Re: William Dick Lagoons Site
Geraghty & Miller Proposed Hydrogeologic Work

SUBJECT: Additional Hydrogeologic Work at William Dick Lagoon
FROM: Kathy Davies, Hydro
TO: Jack Kelly, RPM

PROPOSED WELL LOCATIONS
 WILLIAM DICK LAGOONS, WEST CALN TOWNSHIP, PENNSYLVANIA
 CHEMICAL LEAMAN Exton, PA

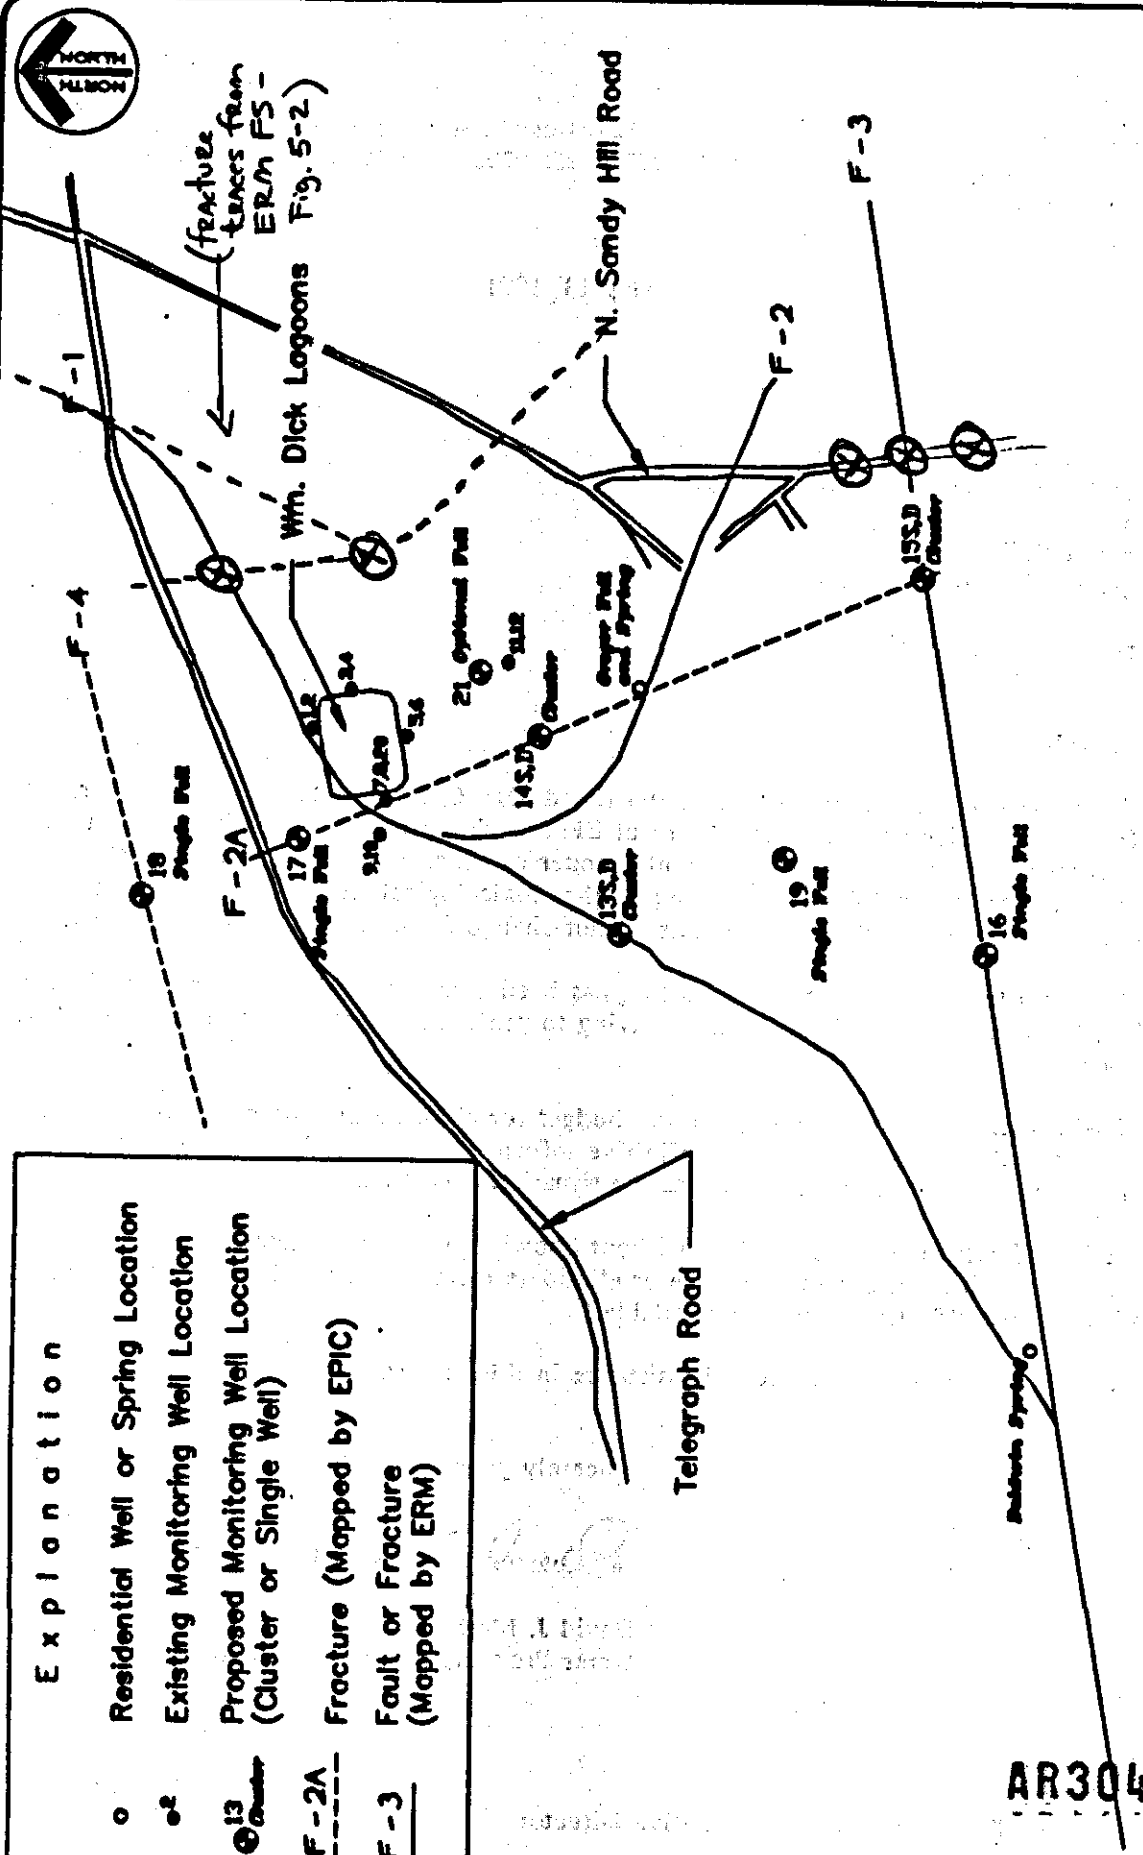
The approximate well locations proposed by G&M seem to be appropriate as an initial step in further characterizing the

site. If you are interested in gaining more insight to the interconnectivity of the site and contaminated residential wells, then I think we need to look at available well construction information for the residential wells and add a few additional monitoring wells between the lagoons and the home well. I have sketched pertinent geologic features, such as the fault and fracture traces, as well as a few possible new well locations on the attached map.

Added wells per K. Davies 5/9/91
